**Bulletin**

MODEL BENTLEY MARK VI

CLUTCH PEDAL.

FOR INFORMATION:CLUTCH PRESSURE SPRINGS - 10" BORG & BECK CLUTCH.

Fig.1. Section through flywheel and clutch.

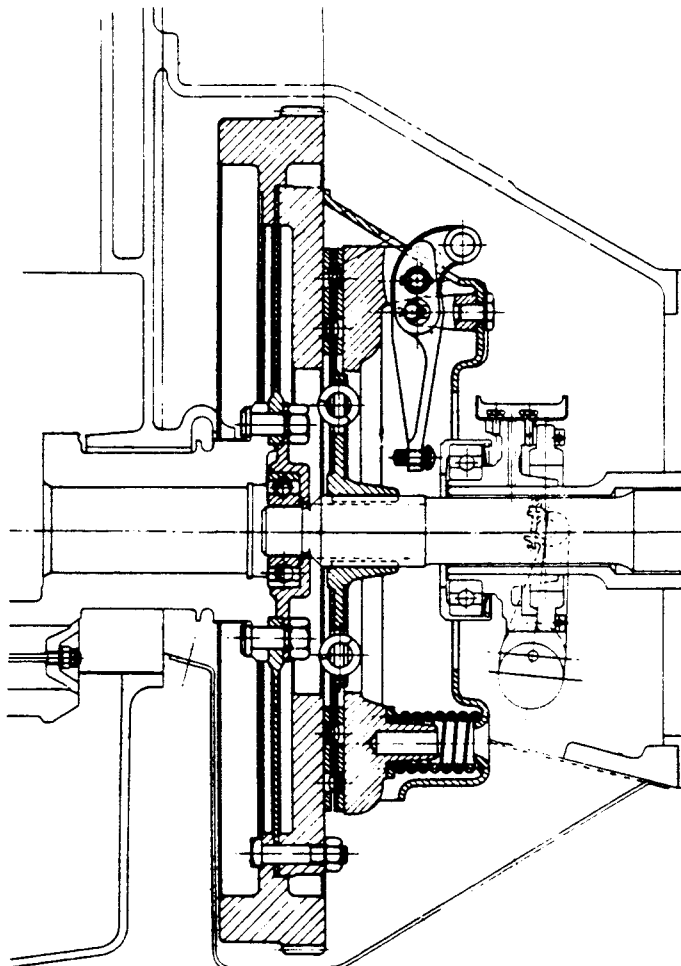
Before resorting to any dismantling for slip, the free travel of the clutch pedal should be measured and adjusted if necessary as follows:-

With the clutch pedal lever against its up-stop under the pedal gap plate, place the edge of a rule against the centre of the side of the pedal and the end of it against the dash, depress the pedal by hand until the clutch release bearing just touches the three release levers of the clutch. Measure the free travel which should be  $1\frac{1}{2}$ " (38 m/m). A turnbuckle adjuster with a central spanning point is provided. Insufficient free travel of the clutch pedal can be one of the causes of clutch slip. If clutch slip is experienced at high engine R.P.M., it indicates that there is insufficient pedal clearance.

Fig.2. Section through flywheel.

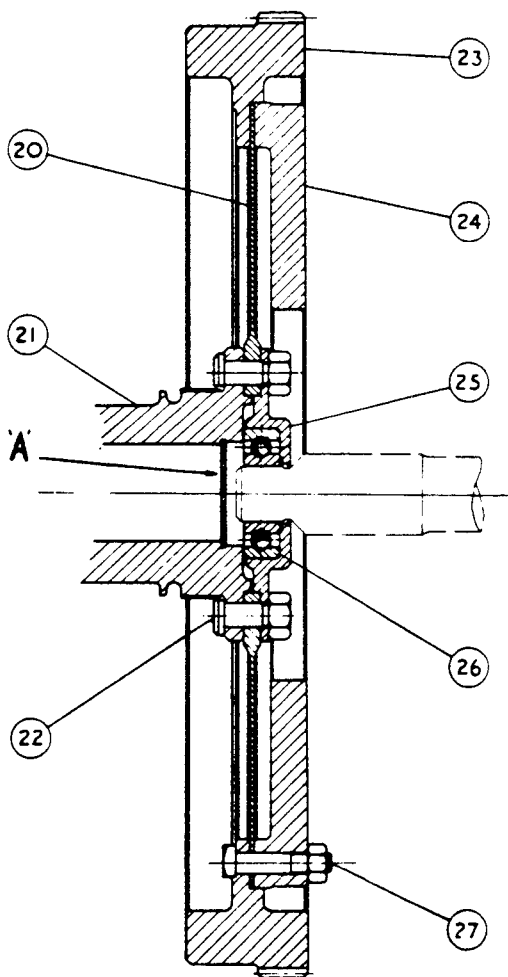
1. Oil leakage past the sealing washer 'A' Fig.2 at the rear end of the crankshaft.
2. Excessive initial loading of grease into the clutch spigot ball bearing (26 Fig.2) of the flywheel, distinguished by radial grease marks on the friction plate (24).
3. Over zealous application of the foot-operated chassis oil pump or a faulty oil restrictor (Type ZEO), allowing too much oil to reach the clutch release bearing (32 Fig.5) eventually working its way along the splines on to the driven plate.

It has been found on investigation, that under certain conditions there is a possibility of an oil leakage past the sealing washer ('A' Fig.2) at the rear end of the crankshaft. If the leakage is sufficient, oil may reach the front facing of the driven plate. In practice, it is likely that the first indication will be a clutch shudder and then a slipping clutch. If after removal of the clutch, oil, apart from grease, is found to be present in the spigot bearing (26 Fig.2), it can be assumed that it is leaking past the sealing washer.

If too much grease has been packed into the clutch spigot ball bearings (26 Fig.2) in the flywheel, then it may eventually find its way on to the friction plate (24) of the flywheel with consequent contamination of the front facing of the driven plate. Remove all traces of grease, oil or foreign matter from the flywheel, friction plate and clutch casing. There should not be a repetition of this trouble, as any excess of grease in the spigot bearing will have found its way out. There is no need to remove the spigot bearing for cleaning purposes.

Whenever there is evidence of oil leakage past the sealing washer, a rubber plug should be fitted as described herein. If however, a rubber plug is not immediately available, then it will be necessary to solder the sealing washer ('A' Fig.2) to the crankshaft as described in Paragraph 1b.

With the clutch removed from the flywheel, remove the crankcase lower half. Remove the nuts from the twelve bolts (22 Fig.2). Providing the nuts have not been over centre punched, it should be possible to use them again. Leaving the flywheel assembly in position on the crankshaft, remove the bearing housing (25) complete with the spigot bearing (26). Remove any surplus oil or grease from the spigot bearing and housing and do not add any additional oil or grease.

Fig.3. Details of oil sealing plug.

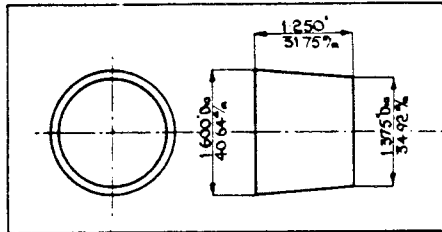
As a service rectification, a conical synthetic rubber oil sealing plug (Fig.3) has been introduced and is shown in position in the bore of No.7 crankshaft journal in Fig.4. Arrangements are being made for supplies of these plugs to be sent to all Overseas Retailers. Will Retailers in the U.K. kindly note that supplies are available from the London Service Depot.

With the clutch removed from the flywheel, remove the crankcase lower half, taking care to try and avoid damaging the Vellumoid joint fitted between the face of the crankcase and the wheelcase. Before fitting the rubber plug, it will be necessary to drill a 1/16" dia. (1.5mm) air escape hole in the centre of the existing sealing washer. Prior to drilling, and to prevent any drilling swarf from dropping into the spigot bearing (26 Fig.2), cut a piece of paper about 1 1/2" (38mm) wide, grease it on one side and then fold it in cylindrical form so that the greased side is on the interior, pass it through the spigot bearing and up to the face of the sealing washer. After drilling the washer, remove

burrs from hole and then carefully remove the paper tube, together with all traces of swarf which will be found to be trapped on the greased side of the paper.

Fig.5. Section through clutch release bearing and trunnion.

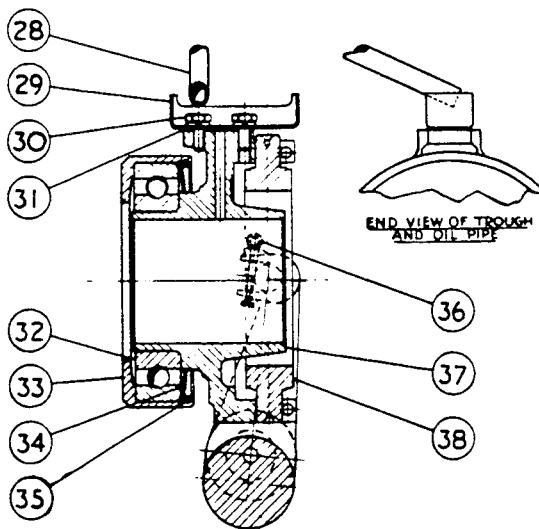
The above will probably allow too much oil to reach the clutch release bearing (32 Fig.5) and eventually find its way on the rear facing of the driven plate assembly. The chassis oil pump should only be operated in accordance with the instructions given in the Owners Handbook i.e. "Depress

If the clutch has been removed for the purpose of fitting a new driven plate assembly, then prior to refitting the gearbox to the clutch casing, ascertain that the oil feed pipe (28 Fig.5) to the oil trough of the clutch trunnion is correctly positioned above the trough. The end of the pipe should be approximately over the front setscrew (i.e. the one nearer to the flywheel) retaining the trough to the trunnion when the clutch release bearing housing (33) is in contact with the adjusting screws of the three clutch release levers. Check that the oil feed hole from trough to the trunnion is clear. With sufficient oil in the foot-operated oil pump, depress the pedal once and count the number of oil drops delivered to the trough of the trunnion.

Approximately three to five drops should be delivered with each application of the pedal. If either above or below this rate of flow, check the restrictor elbow situated on the right-hand top side of the clutch casing, by replacing with a new one of the same type (ZE0).

If the flow is still too great, then fit a type ZE00 elbow which will give a reduced rate of flow, conversely if there is still insufficient oil delivered, then check for a leakage or pipe breakage at some other point in the centralised chassis lubrication system.

FIG.1 FLYWHEEL AND PRESSURE PLATE - ORIGINAL DIMENSIONS.

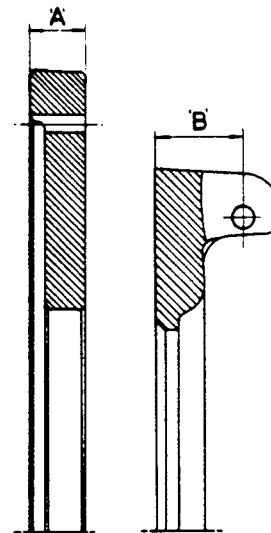
It is permissible to regrind the surface of both the flywheel friction plate and the clutch pressure plate should they show signs of scoring. Only the minimum amount of metal necessary to provide a clean, smooth surface should be removed. Grinding limits and original dimensions are given in Fig.1.

Dimension 'A'	.800" (20.32 m/m)
Grinding Limit	.050" ( 1.27 m/m)

Dimension 'B'	
10" Clutch	1.284" (32.61 m/m)
11" Clutch (Light and Heavy)	1.286" (32.66 m/m)
Grinding Limit	.030" ( .76 m/m)

A surface grinder should be used and a Carborundum stone of grade BA80-N5-VBLU is recommended. The clutch pressure plate may be placed face downwards on the machine table and the backs of the lugs for the toggle levers lightly ground flat to provide a true surface. The plate may then be reversed and the face ground as required.
